# UNITED STATES PATENT AND TRADEMARK OFFICE

APPLICATION NO.	FILING DATE	FIRST NAMED INVENTOR	ATTORNEY DOCKET NO.	CONFIRMATION NO.
10/687,600	10/20/2003	Makoto Morishima	520.43227X00	2551
20457	7590	05/22/2006	EXAMINER	
ANTONELLI, TERRY, STOUT & KRAUS, LLP 1300 NORTH SEVENTEENTH STREET SUITE 1800 ARLINGTON, VA 22209-3873			ALEJANDRO, RAYMOND	
			ART UNIT	PAPER NUMBER
			1745

**Office Action Summary**

## DETAILED ACTION

【図1】

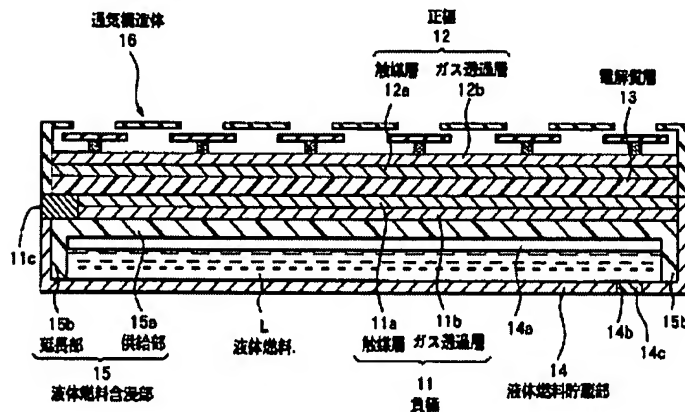
**Figure 1** below of the JP'836 illustrates a power generating device including a negative electrode 11 to oxidize the fuel and a positive electrode 12 to reduce the oxygen and are providing opposing each other with an electrolyte layer interposed therebetween (ABSTRACT/

See Figure 1). As illustrated in Figure 1 below, the positive electrode 12 consists of two electrode plates 12a and 12b; and the negative electrode 11 consists of two electrode plates 11a and 11b. *It is noted that the plurality of both negative electrodes and positive electrodes satisfy the claimed requirement of having opposed anode and cathode electrodes in pairs with the solid polymer electrolyte interposed therebetween. Thus, the electrochemical cell has a plurality of both negative electrodes and positive electrodes.*

Thus, the present claim is anticipated.

【図4】

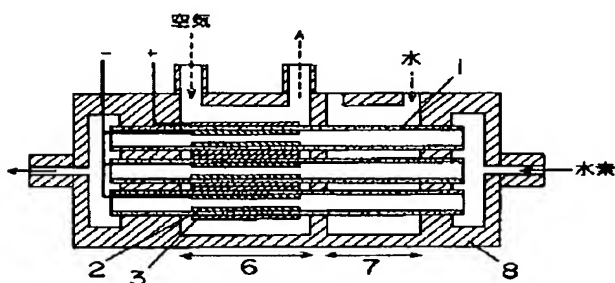
**Figure 4** below of the JP'507 illustrates a solid polymer fuel cell including a plurality of negative electrodes 2, a plurality of positive electrodes and solid polymer electrolytes 1 (Abstract/ See Figure 4). Particularly, a negative electrode is disposed on an inside surface of a solid polymer electrolyte and a positive electrode is formed on an outside surface thereof

(Abstract/ See Figure 4). *It is noted that the plurality of both negative electrodes and positive electrodes satisfy the claimed requirement of having opposed anode and cathode electrodes in pairs with the solid polymer electrolyte interposed therebetween. It is further noted that the negative electrode performs the inherent function of oxidizing the fuel gas, and the positive electrode performs the inherent function of reducing the oxidant.*

Thus, the present claim is anticipated.

Fig. 6

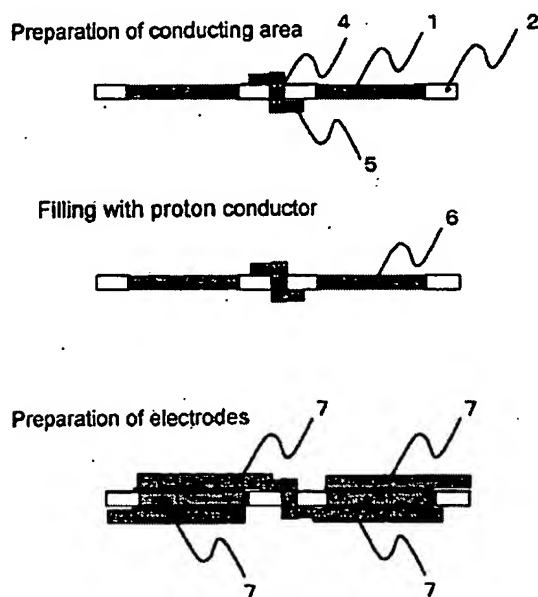
**Figure 6** below of Kidai et al depicts a polymer electrolyte membrane comprising a plurality of electrodes 7 consisting of respective electrode substrates and electrocatalyst layers (P.0058). It is disclosed that connections occur between the anodes and the cathodes located in the opposite sides of the polymer electrolyte membrane, wherein it is preferably to have a structure which interposes electron conductor the polymer electrolyte membrane (P0011). Reference numeral 5 represents the electron conductor through membrane (*the wiring member*

which electrically connects adjoining electrodes); reference numerals 1 and 2 represent respective porous area and non-porous area of the polymer electrolyte membrane (P0025-0031).

**Examiner's note:** It is noted that the plurality of both negative electrodes and positive electrodes satisfy the claimed requirement of having opposed anode and cathode electrodes in pairs with the solid polymer electrolyte interposed therebetween. It is further noted that the negative electrode performs the inherent function of oxidizing the fuel gas, and the positive electrode performs the inherent function of reducing the oxidant.
